ADA Curb Ramp New Construction Inspection Form (Perpendicular)

NW 309th Ave

24952.54

NW Timeric Dr

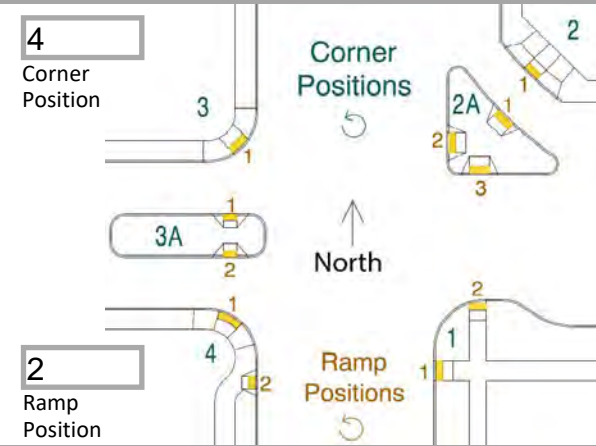
☒

☒

Failure, poor craftsmanship, warped turn space
